Bulletin No.: 09047B
Date: February 2016

Recall Bulletin

SUBJECT: Engine Compartment Fire

This bulletin is being revised to update the correction, service procedure, parts information and the warranty transaction information. Please discard all copies of bulletin 09047A.

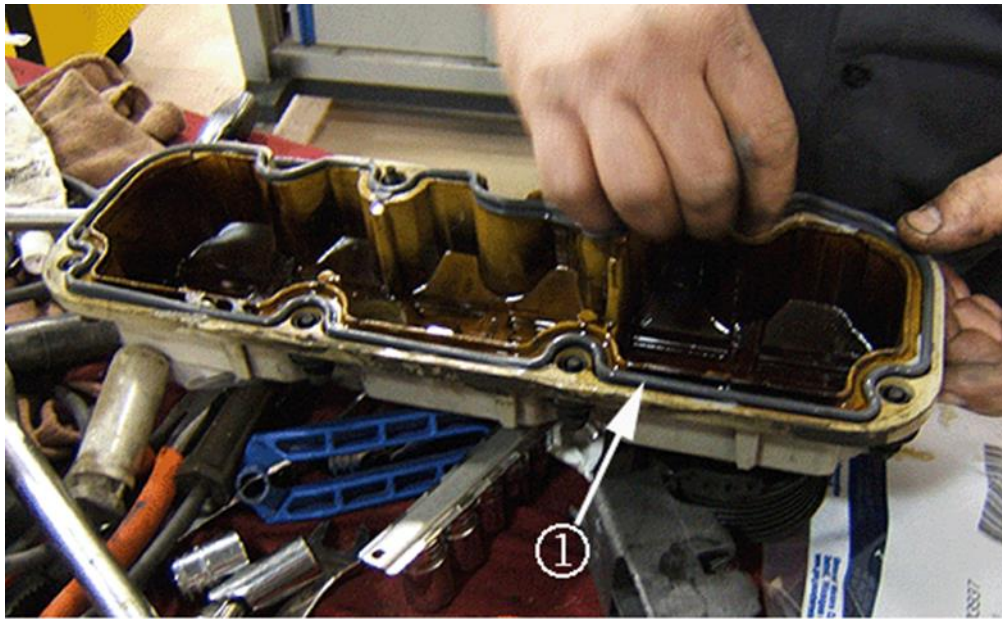
4. Remove the left or front engine valve rocker arm cover (1) and discard.

4.1. Remove the valve cover bolts.

4.2. Remove the valve cover from the engine cylinder head.

4.3. Remove the valve cover gasket.

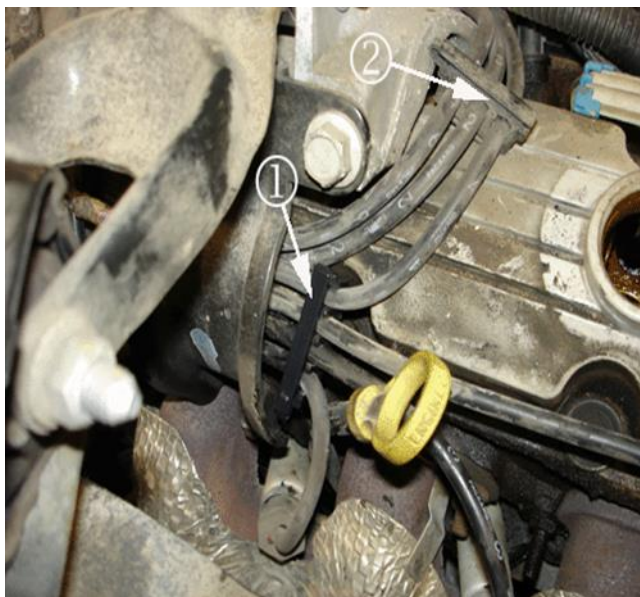
5. Install a new left or front valve cover gasket (1) into the new valve cover and make sure that the valve cover gasket is seated properly in the valve cover groove. The old valve cover is shown for illustrative purposes only.
 - 5.1. Install the six valve cover bolts and the six grommets into the valve cover.
 - 5.2. Apply medium strength thread lock compound (blue) to the six valve cover bolt threads.
 - 5.3. Install the valve cover and gasket (1) to the cylinder head.
 - 5.4. Tighten the valve cover bolts to 10 Nm (89 lb in).
6. Install the 1-3-5 spark plug wires to the ignition coils.

2257363

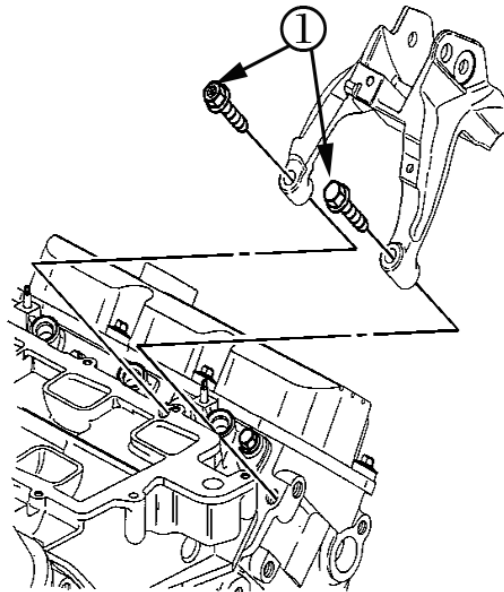
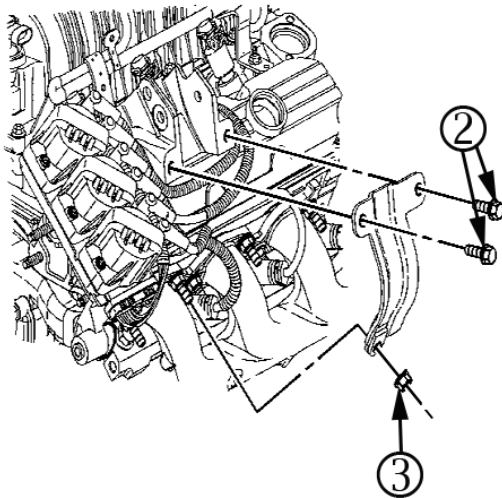
7. Ensure that spark plug retainer (1) is connected to spark plug wire 4 and spark plug wires 1, 3, and 5. Make sure that spark plug wires 2, 4 and 6 are secured to the original retainers and under the left engine mount strut bracket (2).

Note: Do NOT position the retainers above an exhaust runner.

8. Ensure that spark plug wires 3 and 5 are routed behind the oil level indicator and lift bracket. Verify that spark plug retainers (1 and 3) are positioned above the #1 and #3 cylinder spark plug wire boots as shown above. Verify that spark plug retainer (3) is approximately 50mm (2 in) from the oil level indicator (2).
